Massachusetts Office on Disability

October 15, 2012

This report is a follow up to the site visit conducted on September 13, 2012 of Whitman Park located in Whitman. At your request, a site visit was conducted to assist you in identifying the current architectural barriers that persons with disabilities encounter when visiting this historic park. This report shows that several aspects of the park have inaccessible features including routes to programs such as the playground, picnic area, ball parks, basketball court, exterior and interior paths, and band stand. It is our understanding that significant improvements have been made to the park including the installation of new curbing, curb cuts, lighting, seating, plantings, waste management, ball park improvements, pond retention wall and fountain mechanics, and the installation of stairs to the bandstand to which the total amounts to over \$500,000 in costs. This report cites the 2006 revision of 521 CMR enforced by the Architectural Access Board as well as the federal ADAAG with the assumption, based on newspaper articles and your assertions, that the new work performed was started in 2007.

Image -5: Maple and Park Ave.

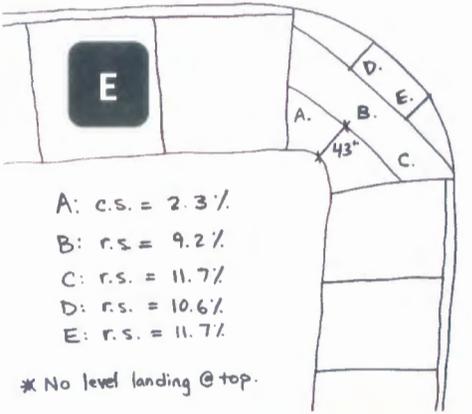
There are at least two non-compliant curb cuts located on Park Ave. The newest curb cut at the corner of Maple Ave. and Park Ave. has a non-compliant slope. The other existing curb cuts do not have compliant reciprocal curb cuts on Park Ave.

Current Conditions/Location	521 CMR Rev. 2006 (AAB)	ADAAG	Pictures
<p><i>Curb Cut / Play area</i> – Non-compliant curb cut near east ball park area at Maple and Park Ave.</p> <p>Curb cut has multiple non-compliant slopes. There is no level landing at the top of the curb cut.</p> <p>There is no reciprocal curb cut on the other side of Maple Ave. and Park Ave.</p> <p>*Note: Other non-compliant items may be present in addition to the items listed above.</p>	<p>21.2.1 <i>Curb cuts</i> are required at each corner of each intersection, located within the crosswalk and/or the pedestrian path of travel.</p> <p>21.3 The least possible slope should be used for any ramp. The maximum slope shall be one-in-12 (1:12). The maximum cross-slope for any <i>curb cut</i> shall be 1:50 (2%).</p> <p>21.6.1 Landing width: Where a perpendicular <i>curb cut</i> is provided, a landing the width of the <i>curb cut</i> shall be provided at the top of the <i>curb cut</i>. The landing shall be 48 inches (48"= 1219mm) in length. The slope of said landing shall not exceed one-in-50 (1:50) (2%) in any direction.</p> <p>*Note: Other regulations do apply in addition to the regulations listed above.</p>	<p>4.7.1 Location – Curb ramps complying with 4.7 shall be provided wherever an accessible route crosses a curb.</p> <p>4.7.2 Slope – Slopes of curb ramps shall comply with 4.8.2.</p> <p>4.8.2 Slope and Rise – The least possible slope shall be used for any ramp. The maximum slope of a ramp in new construction shall be 1:12. The maximum rise for any run shall be 30 in.</p>	 <p>A: c.s. = 2.3% B: r.s. = 9.2% C: r.s. = 11.7% D: r.s. = 10.6% E: r.s. = 11.7%</p> <p>* No level landing @ top.</p>  <p>Non-compliant curb cut</p>
